SECTION 009113 – ADDENDUM FOUR

- A. Project Name: 22062 Picayune Multipurpose and Band Hall Renovation
- B. Owner: Picayune School District, 706 Goodyear Blvd., Picayune, MS 39466
- C. Architect: Dale | Bailey, an Association, 188 E. Capitol Street, Suite 250, Jackson, Mississippi, 39201
- D. Architect Project Number: 22062
- E. Date of Addendum Four: 13 July 2023

Picayune High School Multipurpose and Band Hall Renovation 22062 Picayune Multipurpose and Band Hall Renovation Picayune, MS

PLAN NOTES

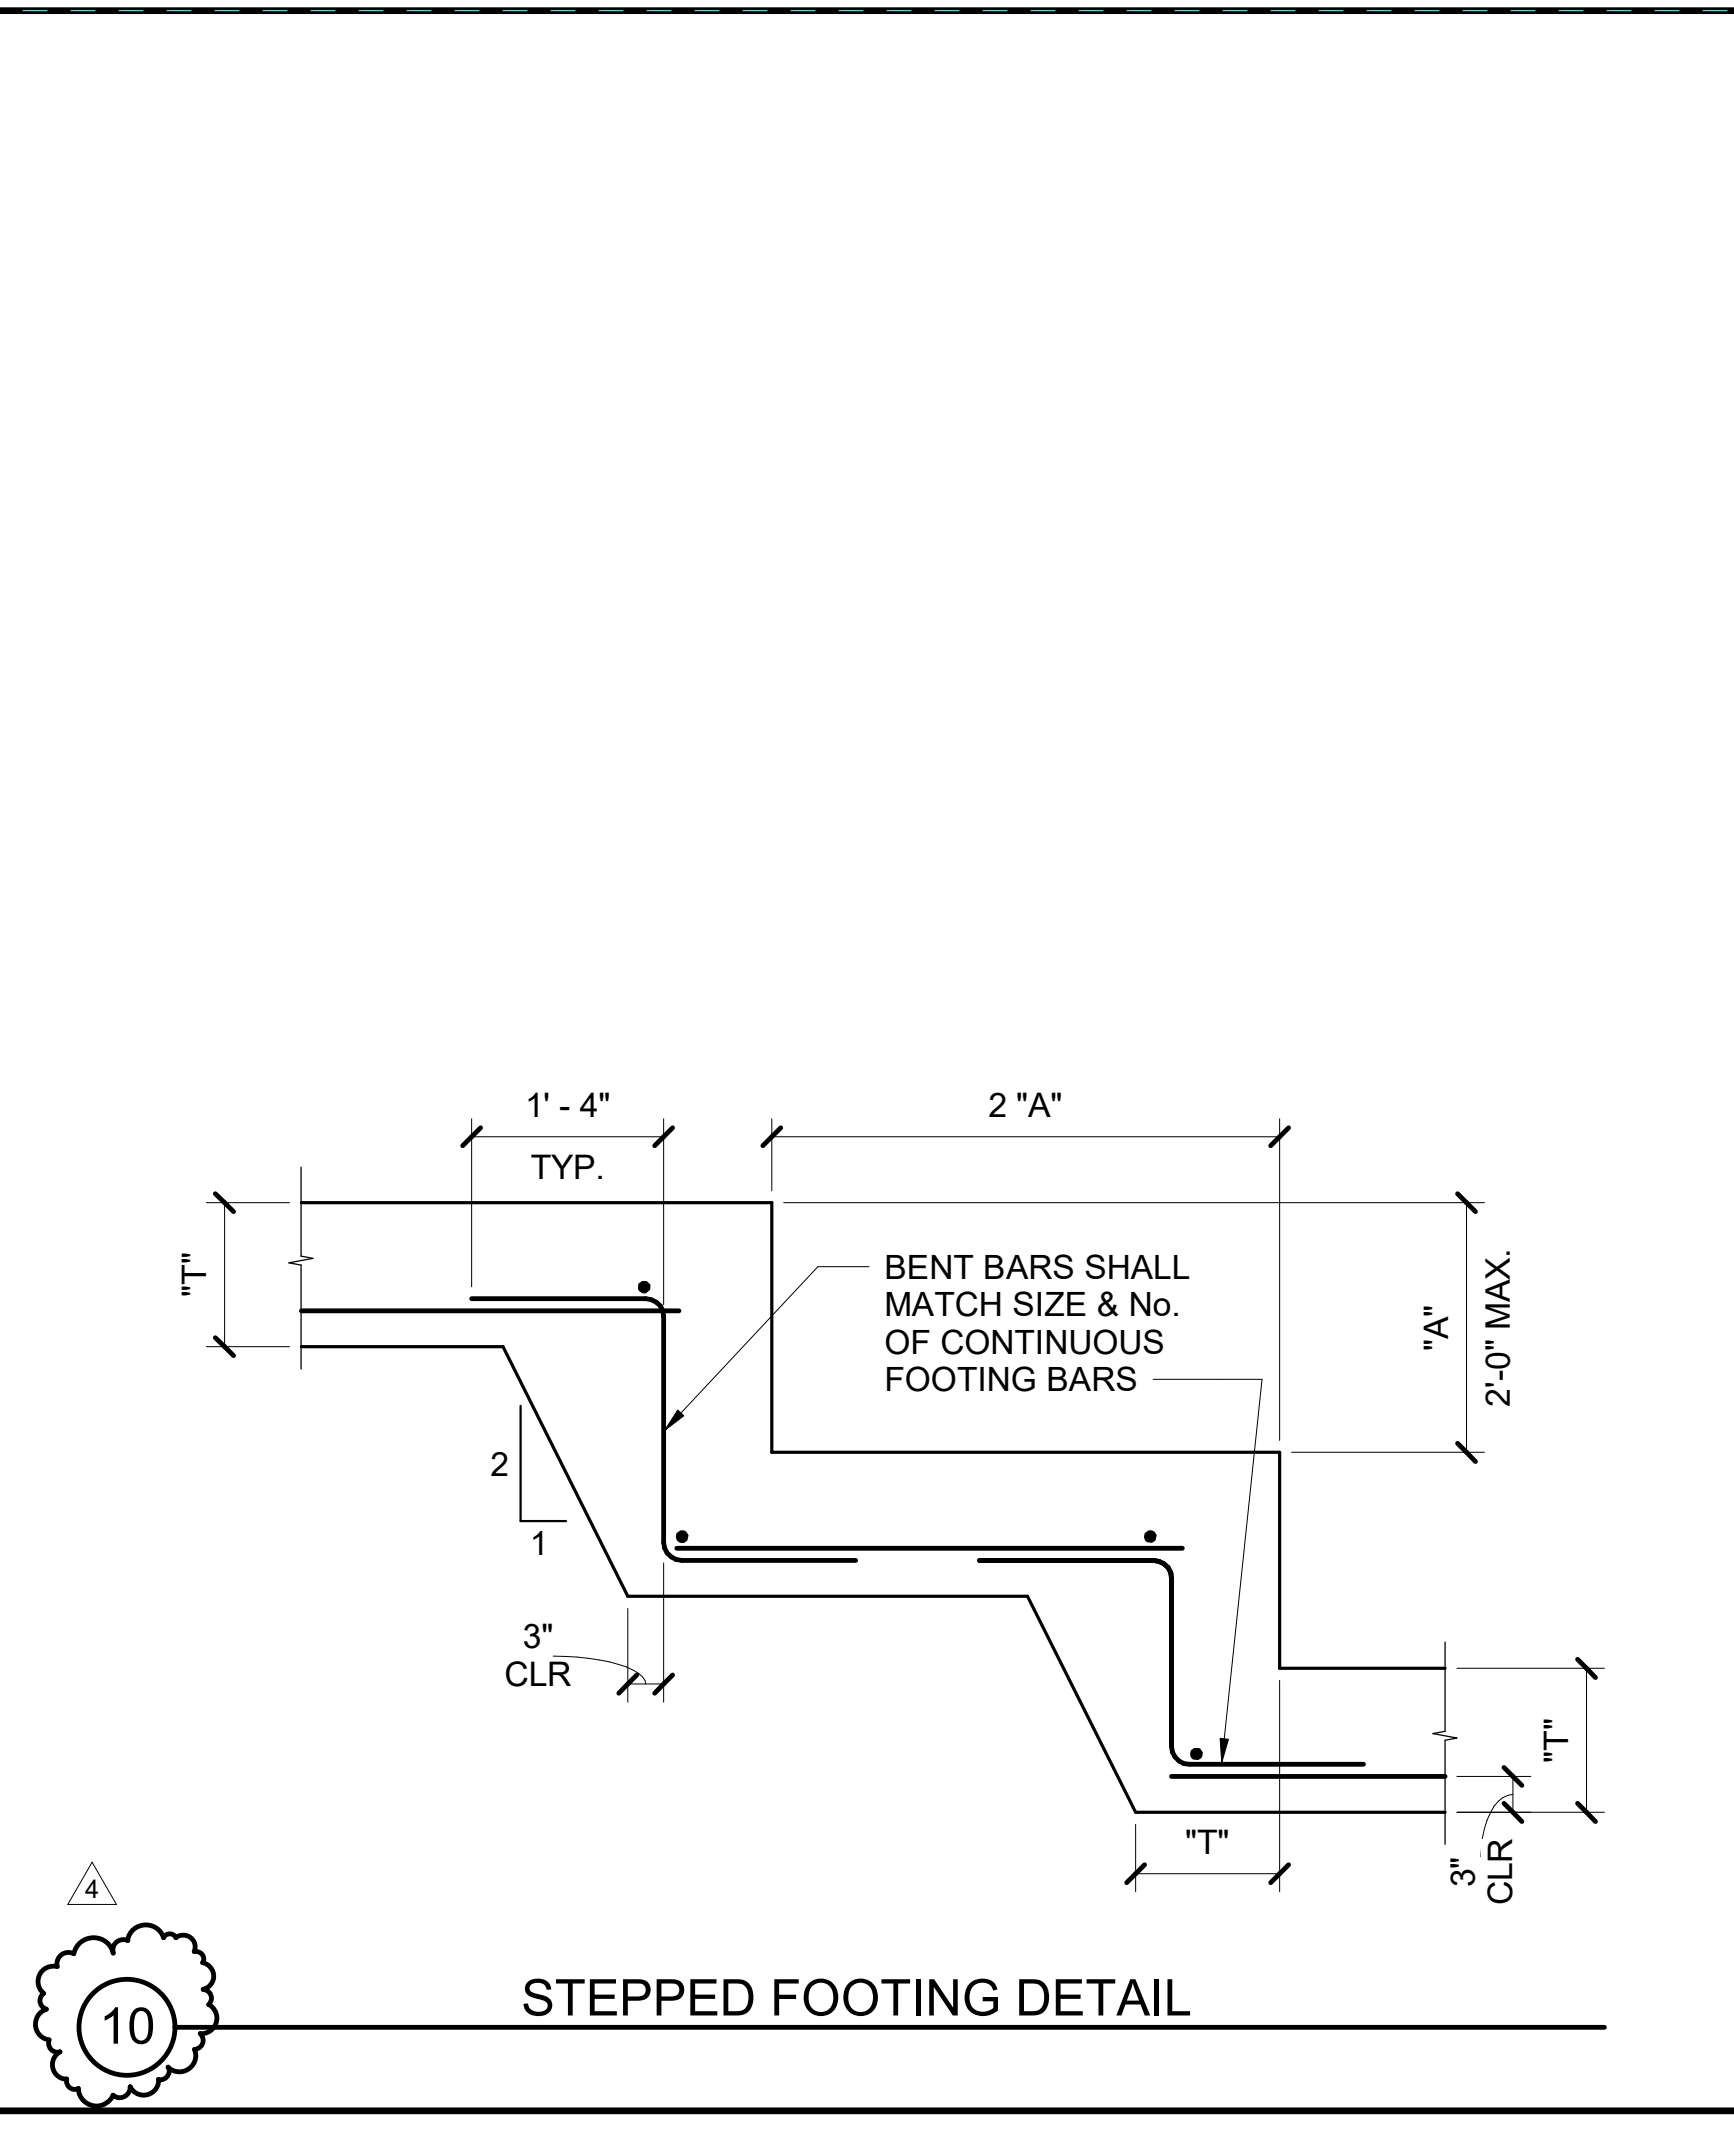
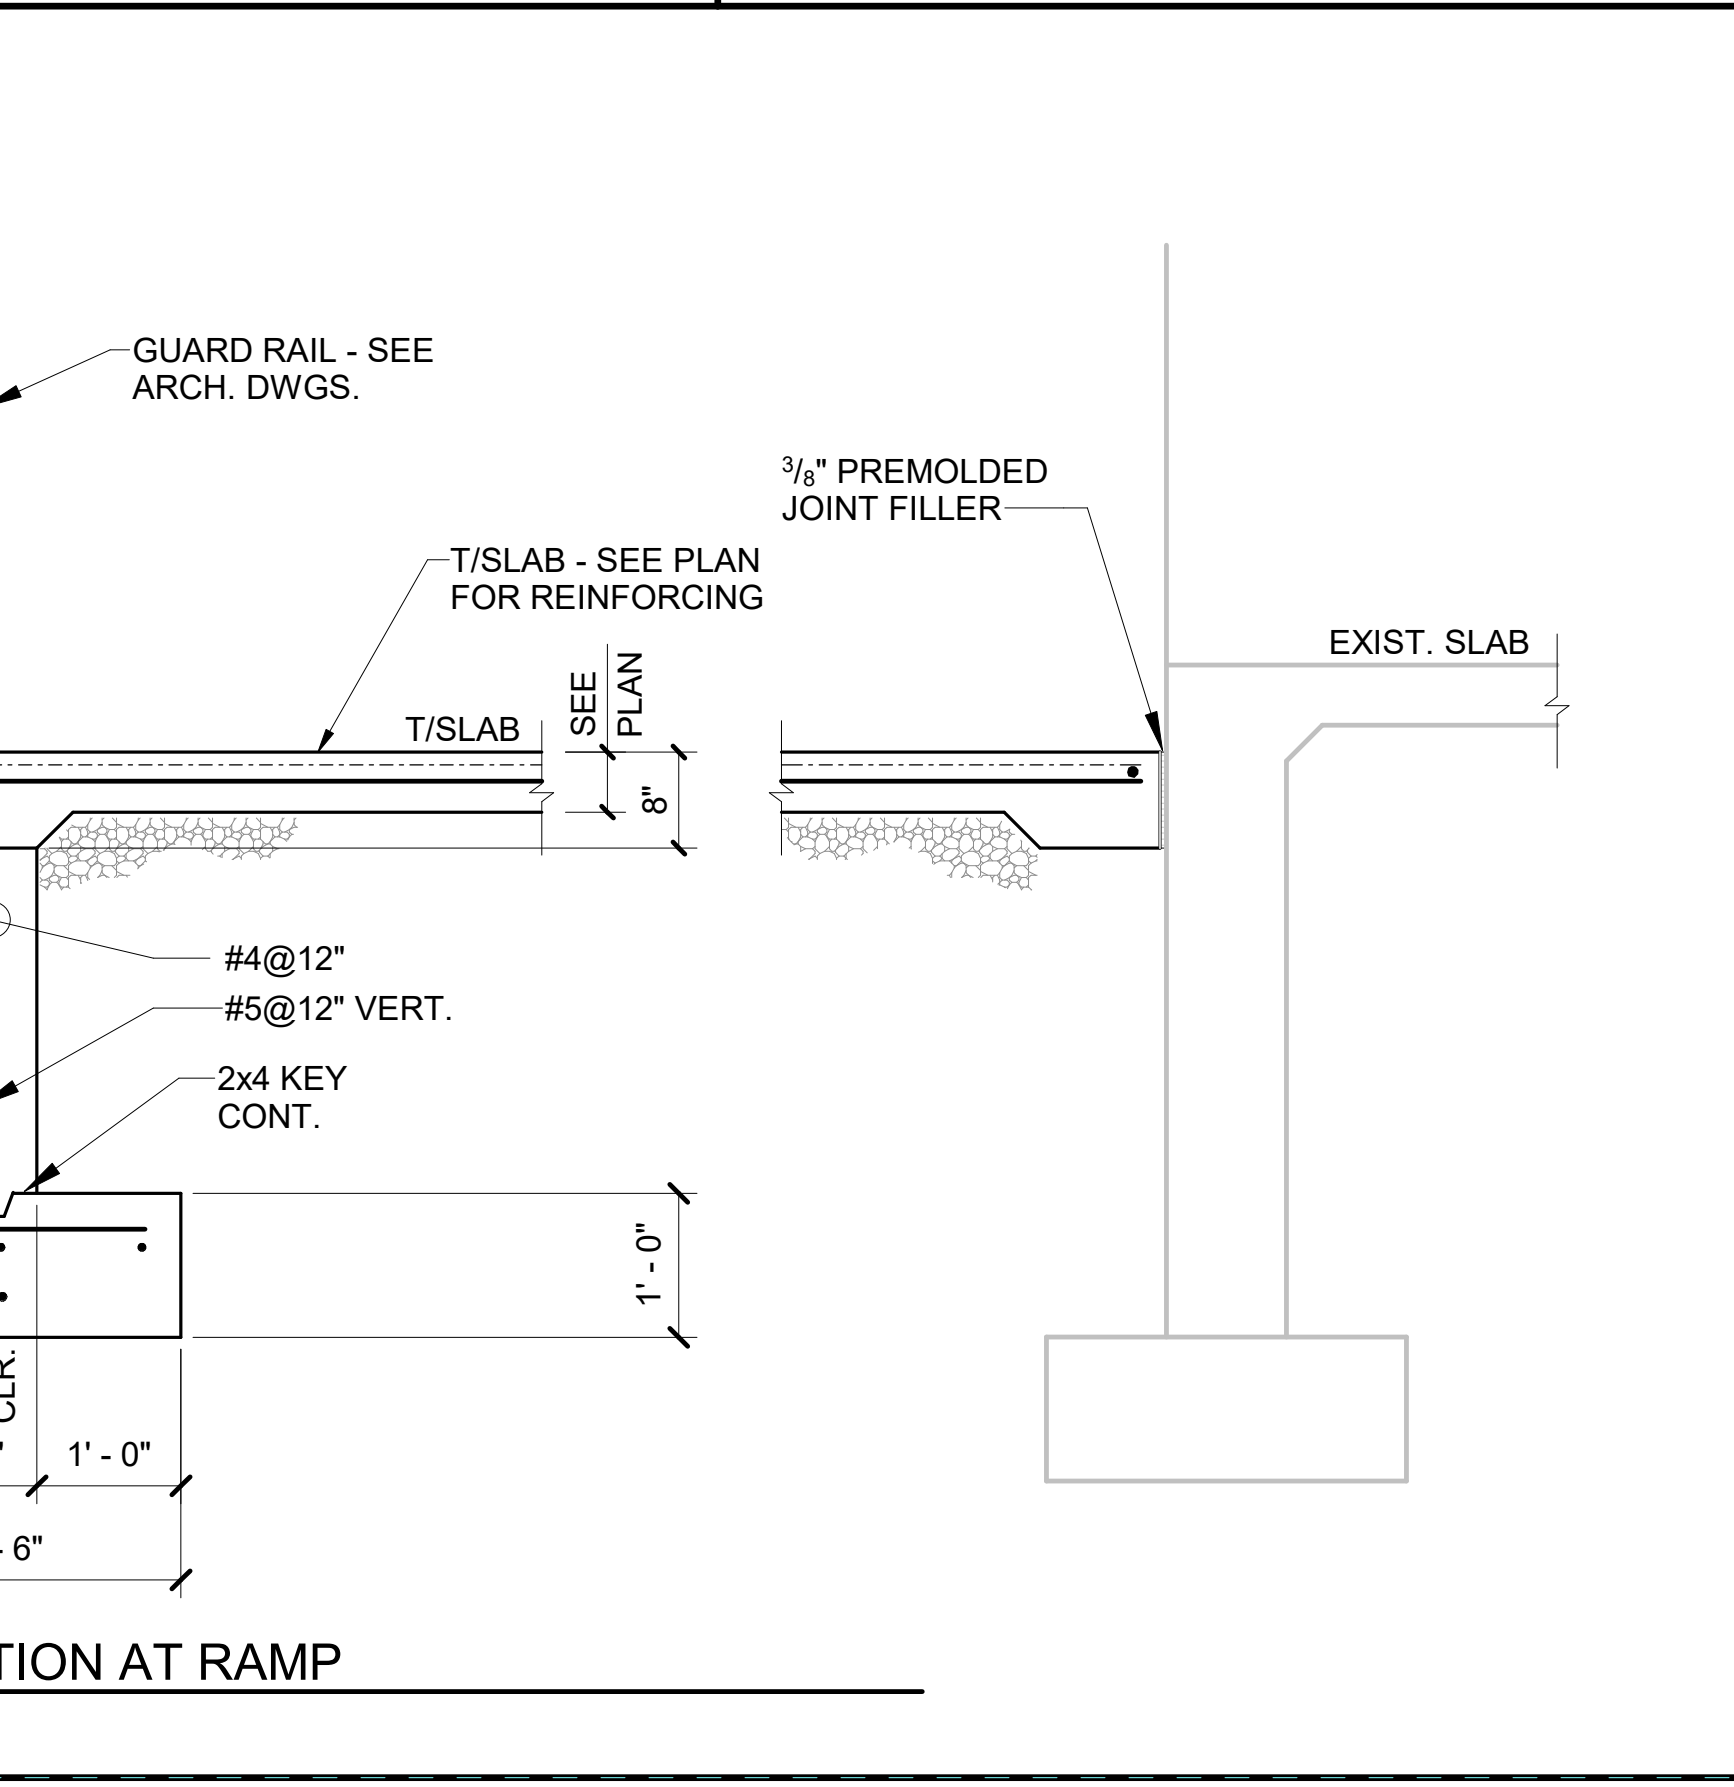
- A. Sheet S-003 – Structural Quality Assurance Plan (Not Re-Issued). Under General, 3rd paragraph: Special Inspector will be hired by the Owner.
- B. Sheet S-101 – Foundation Plans (Re-Issued). Delete this sheet in its entirety and replace it with the attached. Added foundation wall and footing to east side of building along with new sections (7/S-203, 8/s-203, 9/S-203 and 10/s-203) detailing wall and footing.
- C. Sheet S-203 – Foundations Sections and Details (Re-Issued). Delete this sheet in its entirety and replace it with the attached. Added details 7/S-203, 8/s-203, 9/S-203 and 10/s-203.
